<b>JRPP No:</b>	2009STH017
<b>DA No:</b>	DA-2009/1582
<b>PROPOSED DEVELOPMENT:</b>	Construction of Thirteen (13) Storey Commercial Building
<b>APPLICANT:</b>	Design Workshop Australia
<b>REPORT BY:</b>	Theresa Whittaker, Senior Development Project Officer, Wollongong City Council (02) 4227 7481

## Assessment Report and Recommendation

Figure 9 – Building separation – area of non-compliance

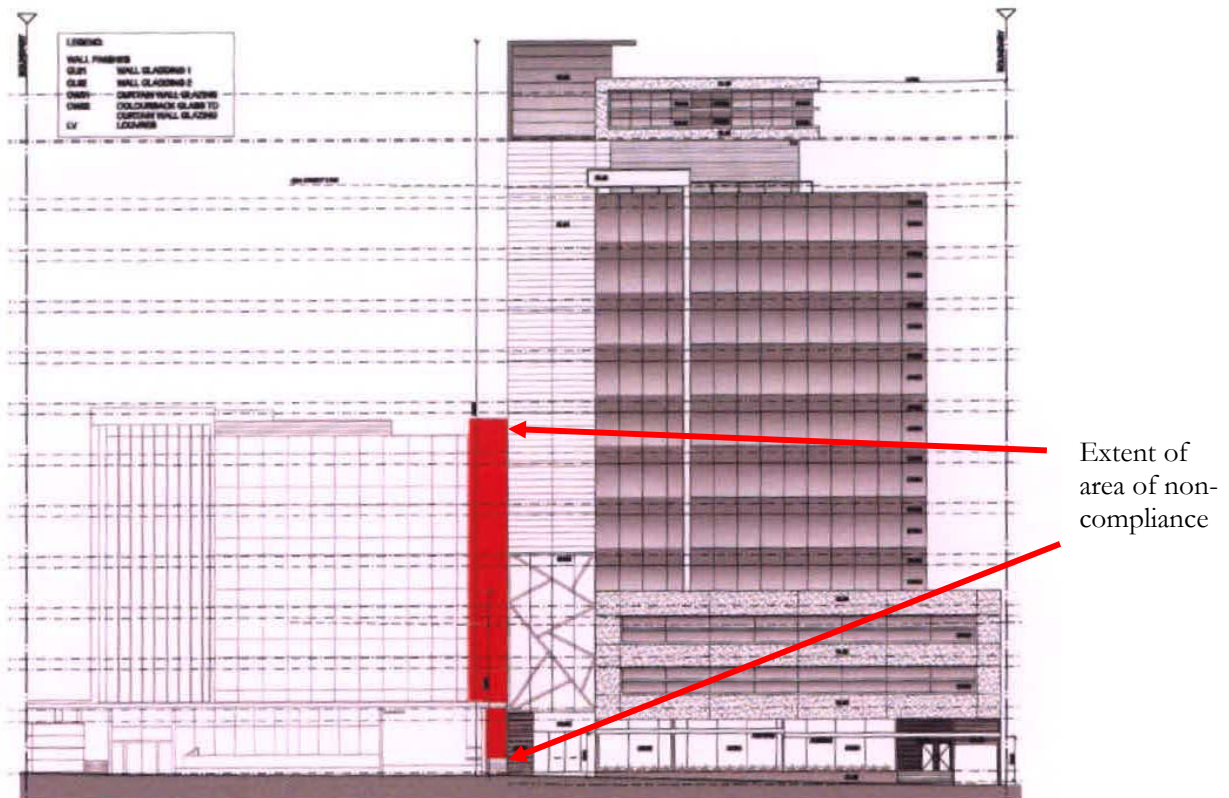
The proposed development provides a building separation of between 1m and 3m between the northern façade of the proposed building and the southern façade of the existing development of Stage 1 of DA-2004/2281 (between ground and level 5 of the proposed building). The area of non-compliance is shown in red in Figure 9 below.”

The applicant’s submission is considered to be acceptable and the variation is supported in this instance. Further comments are provided below in relation to Clause 24 of the LEP. It is noted that the Director-General of the Department of Planning has provided his concurrence to the proposed development.
